Re: Crandall Canyon Mines, C/015/032
C15-003 Midterm Review Task ID# 55011

Attached you will find the application addressing the deficiencies regarding the Midterm review of Crandall Canyon Mine.

Following this letter, you will find the C1 and C2 forms, a summary of deficiencies and detailed actions taken to correct them, and 2 copies of each of the following: edited pages, red line strike out, and maps.

REV: 8	ACAD REF: H AND BC MINE PLAN R8
DATE: 01-13-16	BY: JDS/PJ
SCALE: 1"=600'	PLATE #: 5-2 (BC)

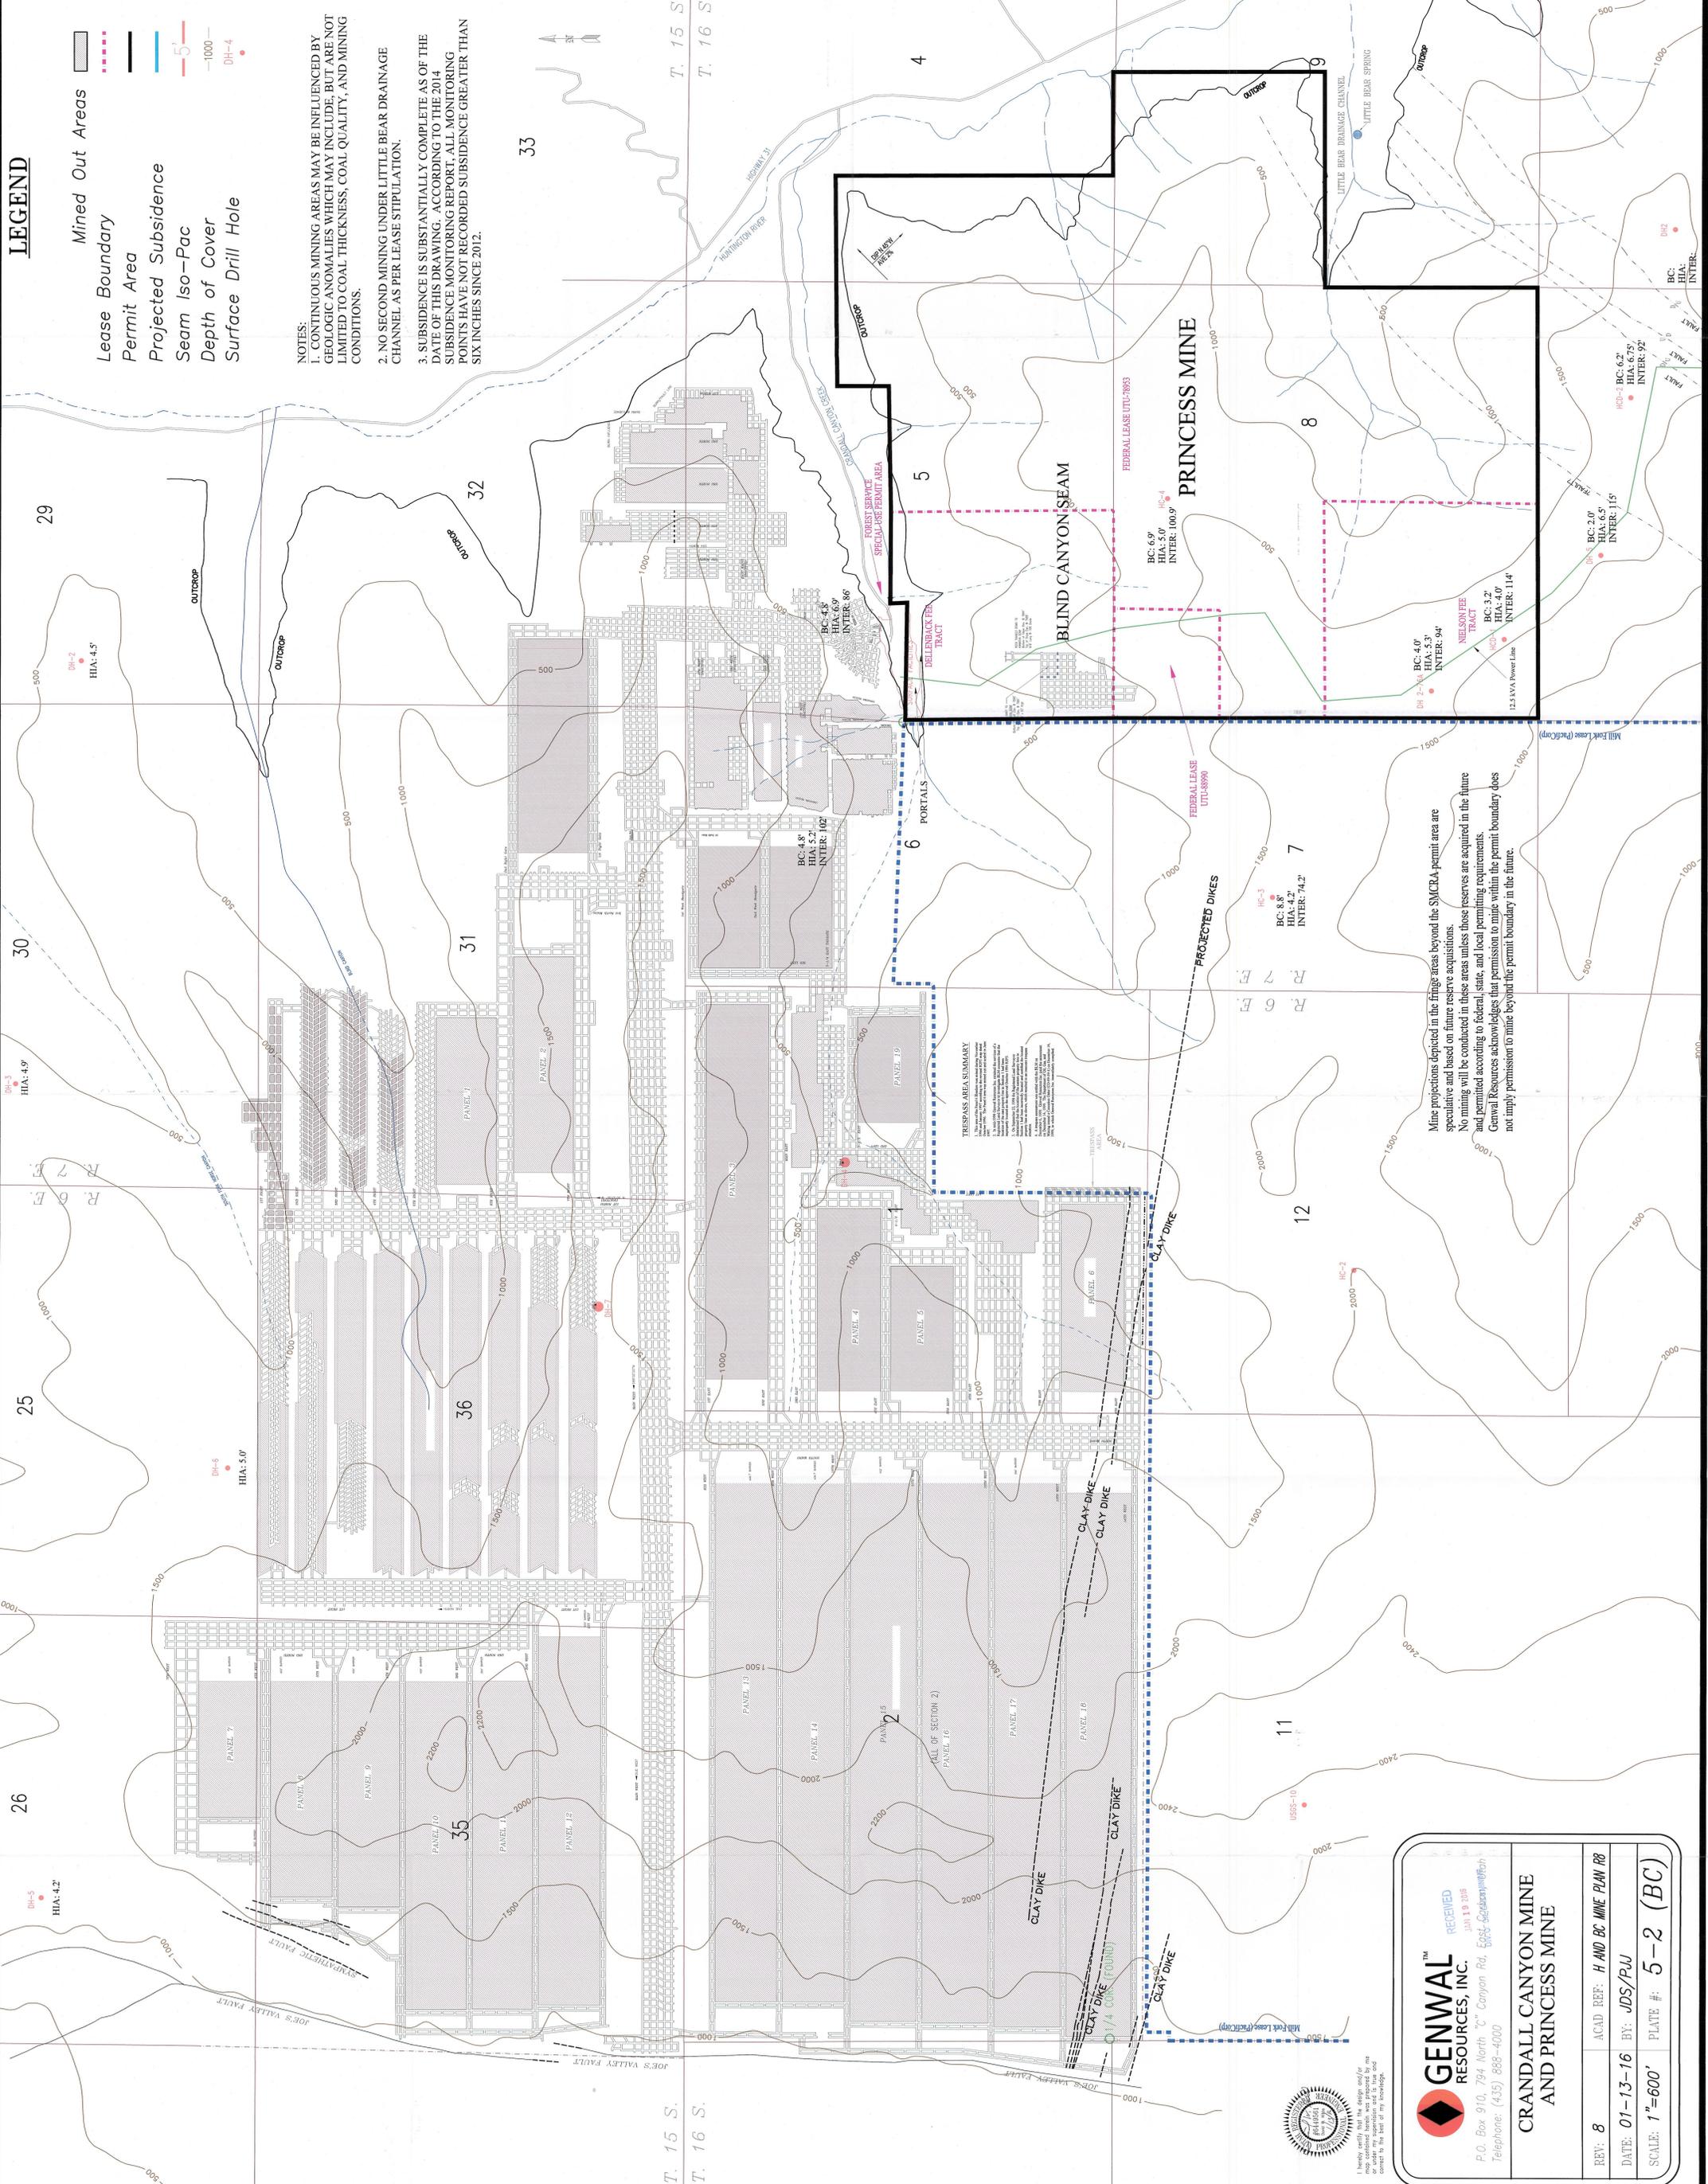
The minimum requirements of R645 are met in the current MRP as the permittee presented a clear subsidence plan for protected are, however, subsidence monitoring requirements have been met as of 2014 and annual subsidence monitoring should be removed from the MRP. Section 5.25.14 of chapter 5 of the MRP states the annual requirement of vertical and horizontal positions of all monitoring points and pins directly over and within the 20 degree angle of draw to the mined area surveyed by aerial photography for that specific year. The subsidence monitoring that subsidence is substantially complete. Plate 5-5 and 5-5(2) detail the coordinates for all subsidence monitoring locations, including monitoring points over areas where the lease has been relinquished. The Permittee has submitted updated annual subsidence information since 2004 for the south Crandall mine and since 2012 for the east mountain reclaimed slide area. As of the 2014 subsidence monitoring report, all monitoring points have not recorded any subsidence greater than six inches since 2012. The permittee should amend the MRP to include demonstration of subsidence is substantially complete, and will no longer be monitored.

NOTES:
 1. CONTINUOUS MINING AREAS MAY BE INFLUENCED BY GEOLOGIC ANOMALIES WHICH MAY INCLUDE, BUT ARE NOT LIMITED TO COAL THICKNESS, COAL QUALITY, AND MINING CONDITIONS.
 2. NO SECOND MINING UNDER LITTLE BEAR DRAINAGE CHANNEL AS PER LEASE STIPULATION.
 3. SUBSIDENCE IS SUBSTANTIALLY COMPLETE AS OF THE DATE OF THIS DRAWING. ACCORDING TO THE 2014 SUBSIDENCE MONITORING REPORT, ALL MONITORING POINTS HAVE NOT RECORDED SUBSIDENCE GREATER THAN SIX INCHES SINCE 2012.
